| APPLICATION NO. | FILING DATE | FIRST NAMED INVENTOR | ATTORNEY DOCKET NO. | CONFIRMATION NO. |
|-----------------|-------------|----------------------|---------------------|------------------|
| 10/509,434 | 06/06/2005 | Tony Day | 18133-213 NATL | 7437 |

Office Action Summary

DETAILED ACTION

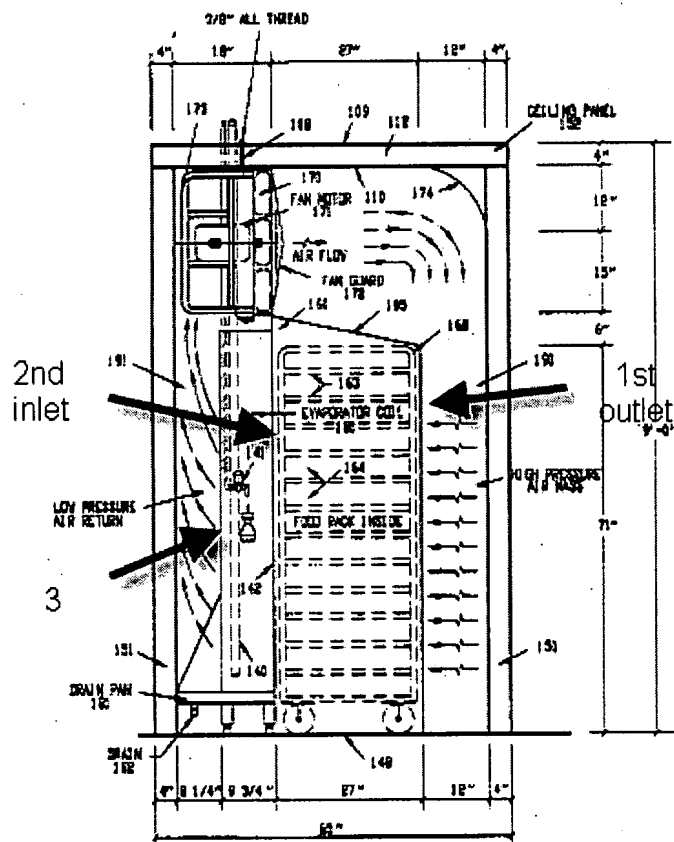
15. Claims 76-78 are rejected under 35 U.S.C. 103(a) as being unpatentable over Ledbetter 5,826,432 in view of Fujimoto 5,952,842 and further in view Applicant's admitted Prior art figure 1.

Ledbetter in view of Fujimoto teaches an invention as discussed above but is silent about an outer enclosure with external panels around the cabinet, an air conditioner between the cabinet and outer enclosure.

Applicant's admitted prior art (fig. 1) teaches the outer enclosure 4, 3, 5 with external panel 7 and 2, and air conditioner 16 between outer enclosure and the cabinet.

It would have been obvious to one of ordinary skill in the art to have the Ledbetter in view of Fujimoto apparatus within Applicant's admitted prior art enclosure and air conditioner in order to provide ventilation of the equipment inside the cabinet (spec. page 6, ll. 13-34 through page 8, ll. 1-27).

(fig. 4 of Ledbetter).

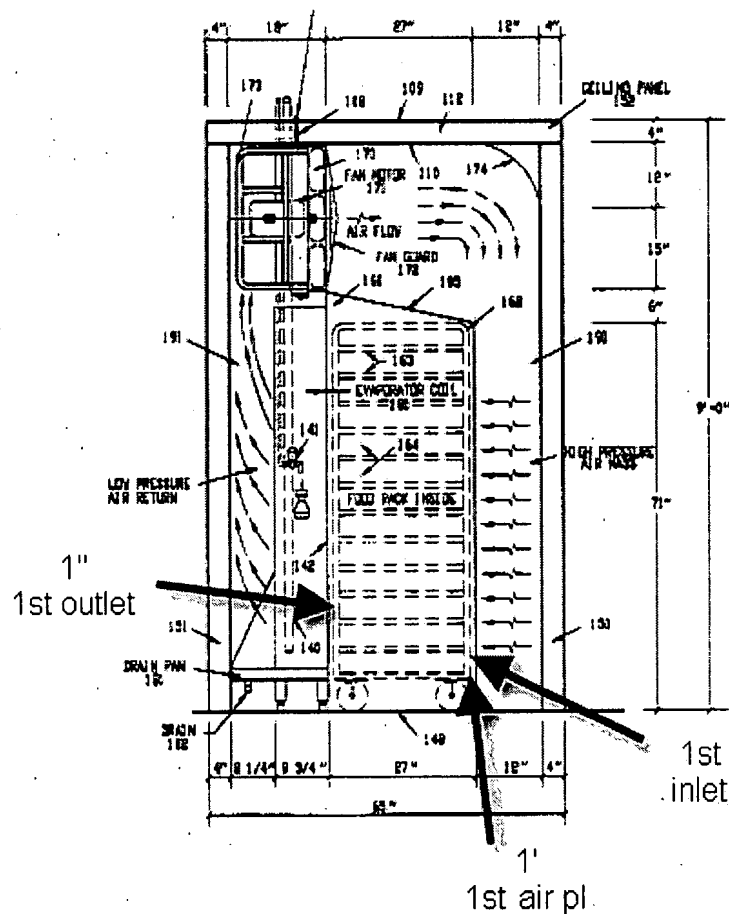
Ledbetter teaches an invention as claimed: a substantially sealed airtight cabinet (fig. 4) sized for housing vertical array of heat-producing units 162 having an exterior shell 109, 190, 151, an interior divider wall 160 disposed inside the cabinet wherein the shell and the divider wall provide an equipment chamber 164, 163, with a first plenum 190 and a first inlet 172 defined by the divider as an at least one substantially vertical slot, admitting the air uniformly over a substantial vertical length (fig. 4), **wherein the divider wall is configured such that the first inlet at least partially vertically overlaps with first plenum 190 (fig. 4) ; said shell and divider wall providing a heat exchanger chamber (on the right sight from divider wall 160) in which the heat exchanger 180 is disposed and an equipment chamber (on the left side from dividing wall**

160) separate from the heat exchanger chamber (fig. 4); a first outlet 1 (see paragraph 16 bellow of this Office Action, wherein examiner marked originally not marked first outlet 1 with darkened arrow for clarification) wherein the first plenum communicates with the openings for exhausting substantially all of the flow through the array in substantially horizontal direction (fig. 4); a second plenum 191 defined between the chamber shell and the array for receiving the air that has passed through the array having a second inlet 2 (see paragraph 16 bellow of this Office Action, wherein examiner marked originally not marked second inlet 2 with darkened arrow for clarification) and second outlet 3 (see paragraph 16 bellow of this Office Action wherein examiner marked originally not marked second outlet 3 with darkened arrow for clarification) defined by the divider wall such that the air is directed horizontally (fig. 4) from equipment chamber 164,163; **a heat transfer means 180 (col. 6, ll. 21-25)** disposed in the cabinet for carrying heat away from the cabinet; a door 210 (fig. 7) configured to provide selective access to the heat-producing units based on at least one of an environmental compatibility inside and outside the cabinet (fig. 11A), when the enclosure around the cabinet is closed (col. 9. ll. 47-63) wherein the doors have independent locks (fig. 11A).

16. Examiner marked originally unmarked elements with darkened arrows for clarification.

Regarding the applicant's argument that that the heat exchanger/evaporator coil 180 and the equipment 163 are disposed in the same chamber, the examiner disagrees ; because the figure 4, of Ledbetter, shows that divider wall 160 divides the the heat exchange chamber (on the left from wall 160) from the equipment chamber (on the right from wall 160).

Regarding the recitation that the first inlet at least partially vertically overlaps with the first plenum, it is clear from the figure 4 of the Ledbetter, that vertical opening/first inlet 172 at least partially vertically overlaps first plenum 190 which starts from fan 170 end ends when entering the elements 163 and 164 (originally shows on figure 4 with darkened arrows).
